AGENDA PORTLAND PLANNING BOARD MEETING

Memorandum Planning and Urban Development Department

To: Brandon Mazer, Chair and Members of the Portland Planning Board
From: Andrew Tufts, Planner
Date: February 5, 2021
Re: 100 BLDG F West Commercial Street (Canal Landing Phase V)
Project #: PL-001220-2020
Meeting: February 9, 2021
CBL: o6o Foo3

Subject: Canal Landing New Yard – Phase V (Building F)
100 West Commercial Street
Level III Preliminary Site Plan Application
Applicant: New Yard, LLC

1 | SOUTH ELEVATION
1/8" = 1'-0"

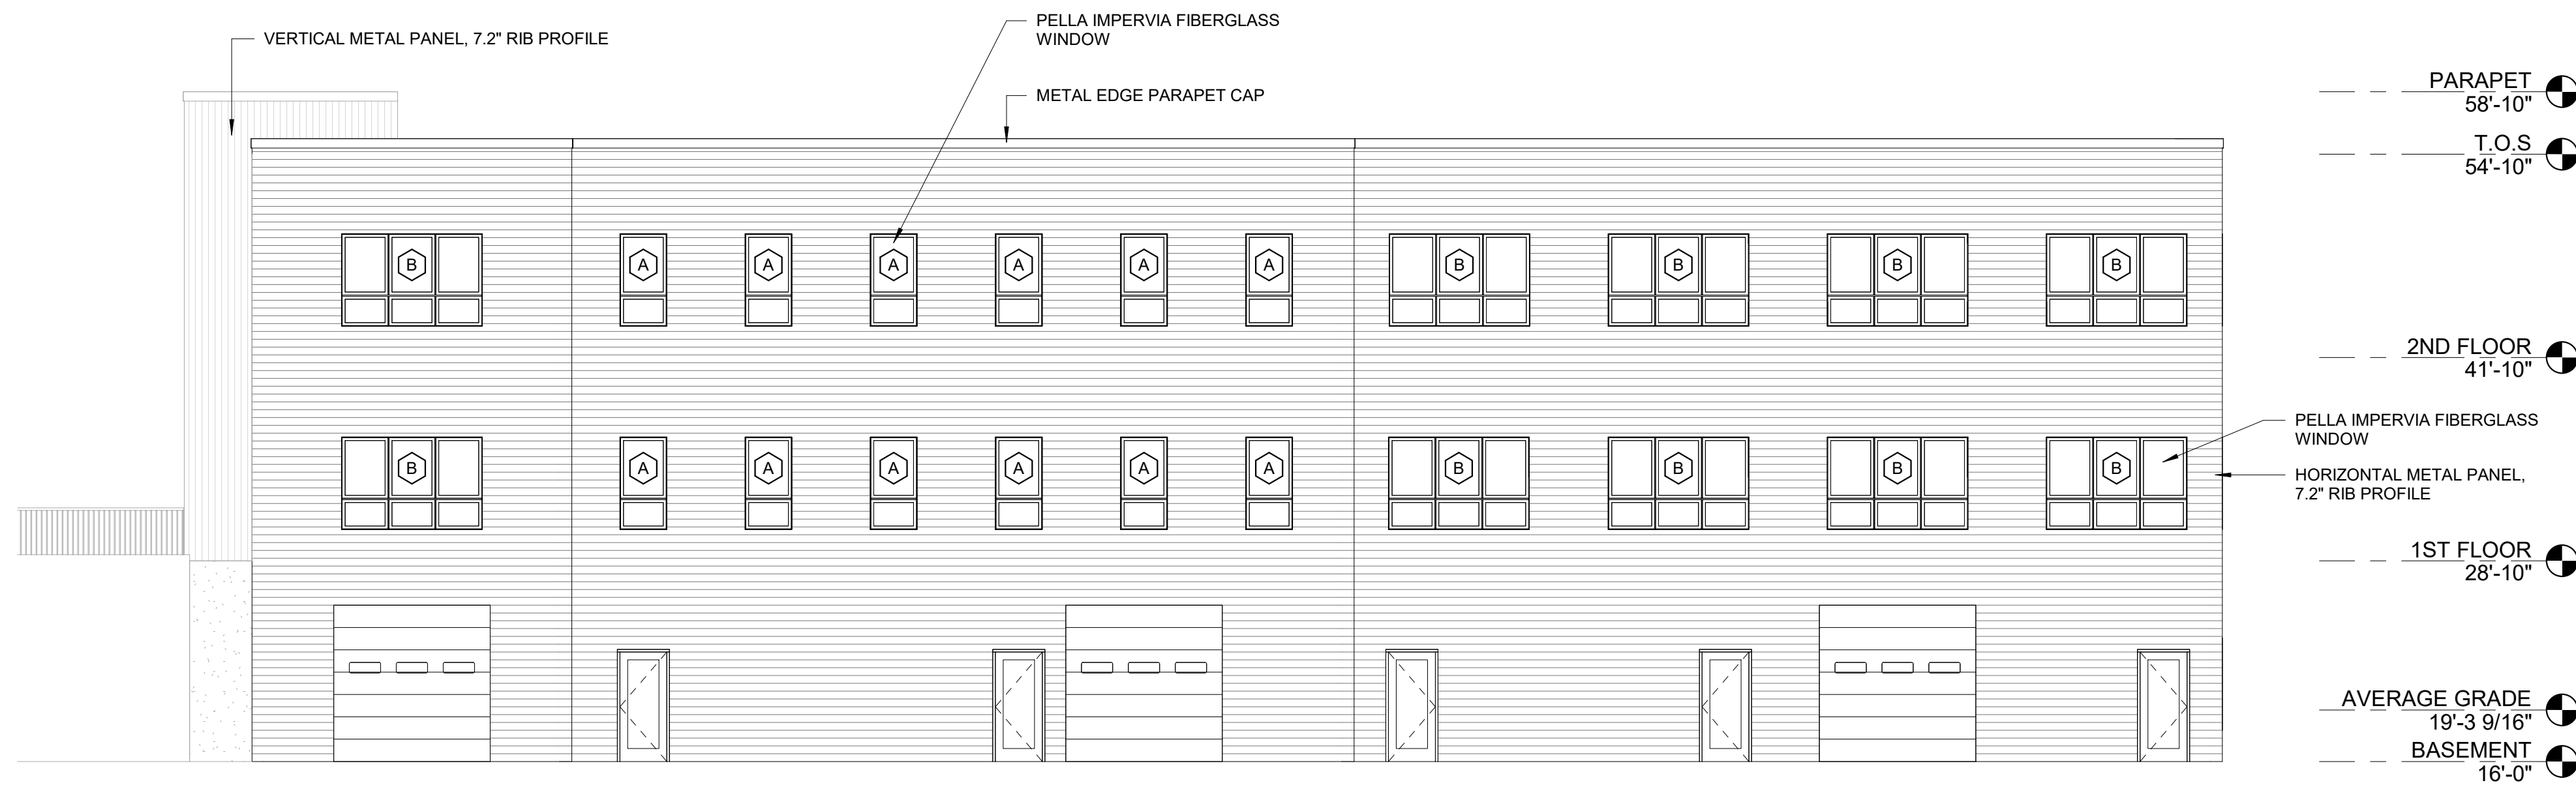
- 3. The average grade of 19.295' provided on Plan A1.00, needs to be shown on the elevation plan, A2.01.*

Response: A revised Plan A2.01 has been prepared and uploaded to ePlan and a copy also accompanies this letter.
